## **TOLEDO-LUCAS COUNTY PLAN COMMISSIONS**

REF: SUP-3002-18

SUBJECT: Request for a Special Use Permit for Used Auto Sales at 4449 Secor Road & 4455 Secor Road.

# OVERALL SITE PLAN

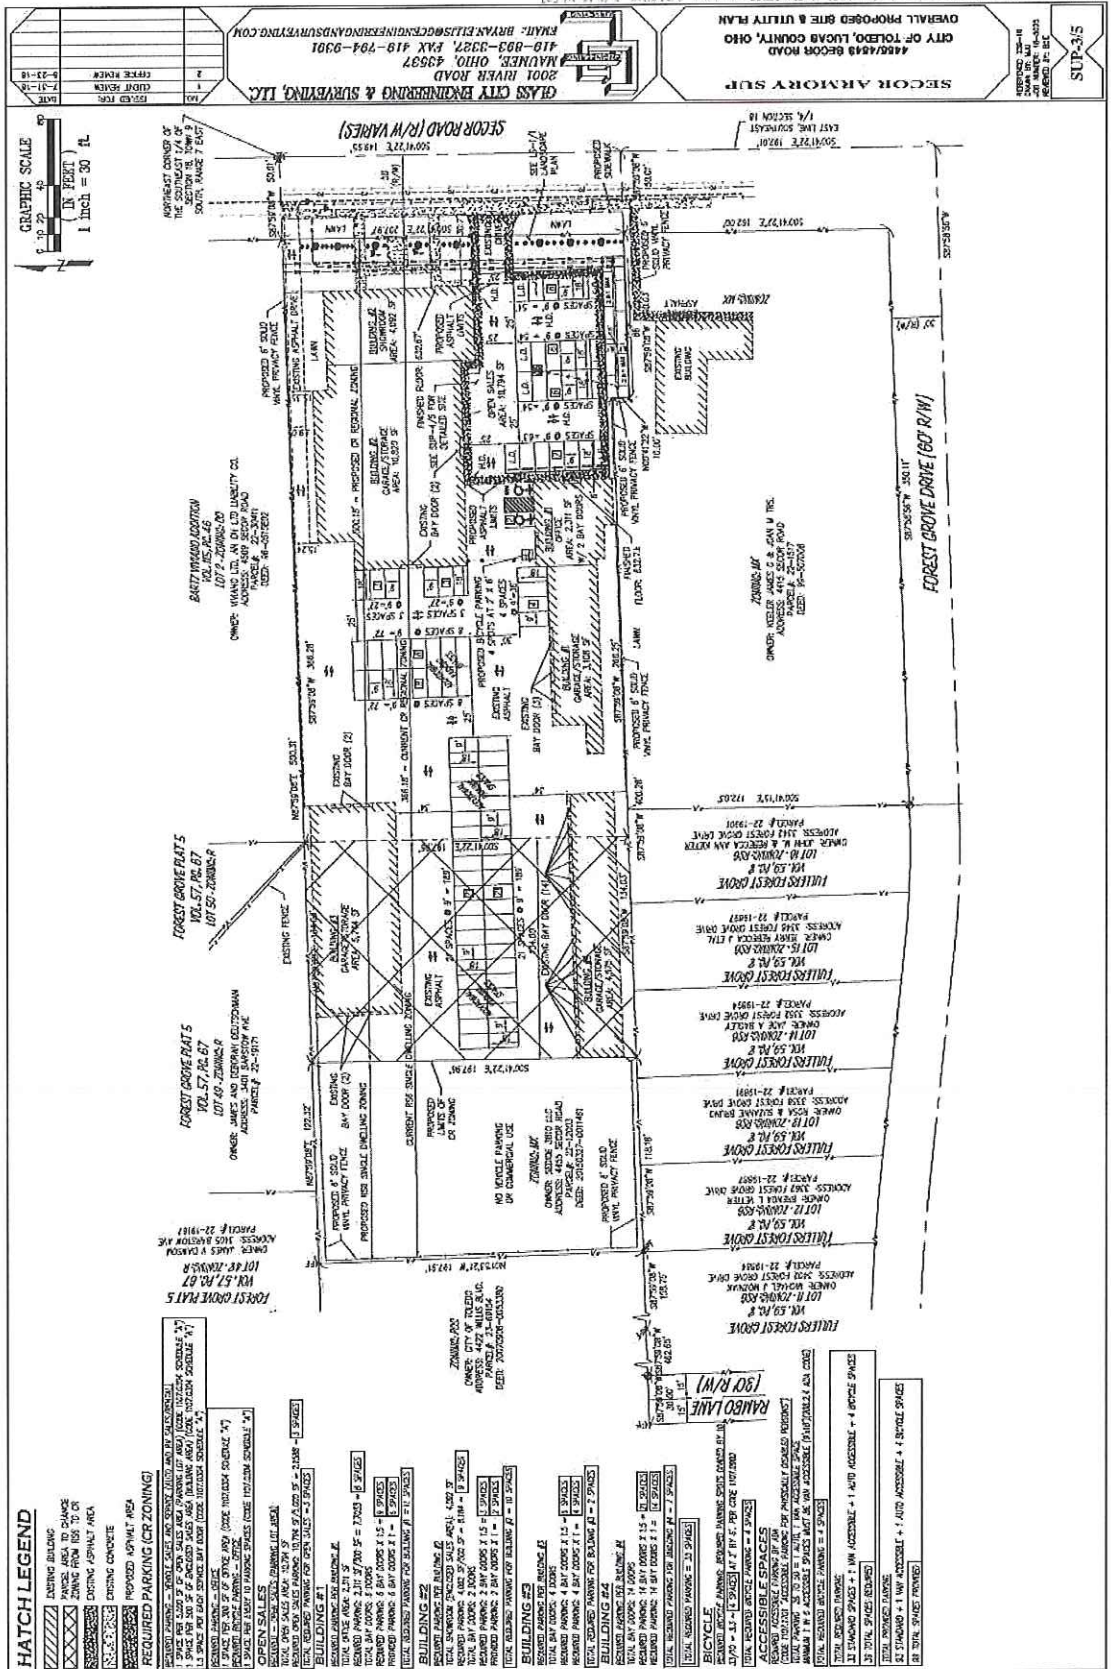
The revised site plan submitted depicts a total of ninety-five (95) parking spaces. Twenty-five (25) spaces are designated for open display vehicles and seventy (70) spaces for customer parking, including two (2) handicap accessible parking spaces. The proposed customer parking spaces meet the minimum number required. However, in accordance with TMC§1107.1700, an additional two (2) handicap accessible automobile parking spaces shall be provided on a revised site plan and listed as a condition of approval.

The Division of Transportation has not objected to the approval of the site plan but has requested the applicant provide a revised site plan addressing multiple items. First, the north access driveway must be signed for one-way traffic with a "do not enter" signs posted. Second, three (3) auto accessible parking spaces and one (1) van accessible parking space is required for the site. Lastly, wheel stops shall be provided at all parking spots that are perpendicular to the buildings. If approved, a revised site plan shall be submitted addressing the Division of Transportation's conditions and listed as a condition of approval.

23. North driveway to be one-way traffic only with "do not enter" signs posted.
24. Three (3) auto accessible parking spaces and one (1) van accessible parking space required per TMC 1107.
25. Wheel stops at all parking spots perpendicular to buildings per TMC 11107.

29. All spaces reserved for the use by persons with physical disabilities shall adhere to the standards outlined in TMC§1107.1700; **not acceptable as depicted on site plan. Two (2) additional automobile handicap accessible parking spaces shall be depicted on a revised site plan.**

- f. Perimeter landscaping must be installed along any parking lot area adjacent to a street, place or driveway, or which is visible from an adjacent property, and shall be ten feet (10') in width; **not acceptable as depicted on site plan. Shall be noted on revised landscaping plan.**

- g. Foundation plantings for the full street-facing building elevation; and landscape areas at major building entrances; **not acceptable as depicted on landscaping plan. Shall be noted on revised landscaping plan.**
